# UNITED STATES PATENT AND TRADEMARK OFFICE

<b>Office Action Summary</b>	<b>Application No.</b> 10/812,011	<b>Applicant(s)</b> LIM, JEONG-SU	
	<b>Examiner</b> Todd M. Epps	<b>Art Unit</b> 3632

This is the second Office Action **final** for serial number 10/812,011, Monitor Apparatus, filed on March 30, 2004.

FIG. 1  
(PRIOR ART)

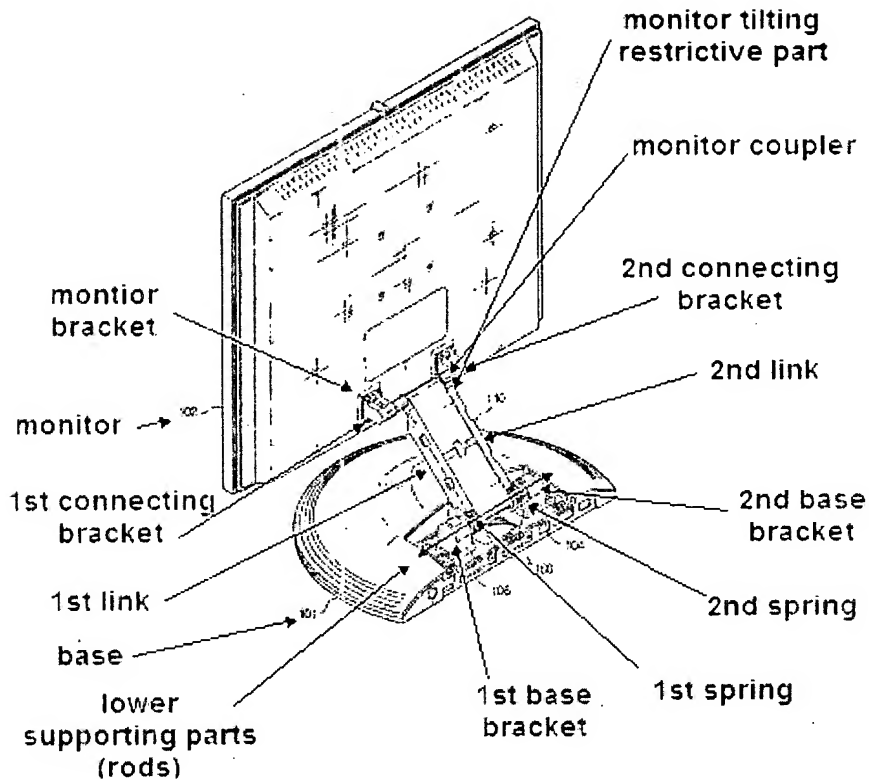
In response to applicant's argument that the "Description of the Related Art" (fig. 1) does not disclose a connecting bracket rotatably combined to the monitor. The Examiner clearly disagrees. With reference to the office action above and the drawing below, the applicant will see that the above reference does in fact teach wherein a connecting bracket rotatably combined to the monitor. The figure shows the connecting bracket rotatably combined to the monitor as the monitor moves.

Furthermore, applicant argues that the "Description of the Related Art" does not disclose a base bracket having first and second lower supporting parts to rotatably support lower parts of the first and second links, respectively. The Examiner clearly disagrees. The Examiner recognized that there are rods or pivot parts on both ends from the base brackets through the springs and attached to both lower links. The rods are being used as support lower parts.
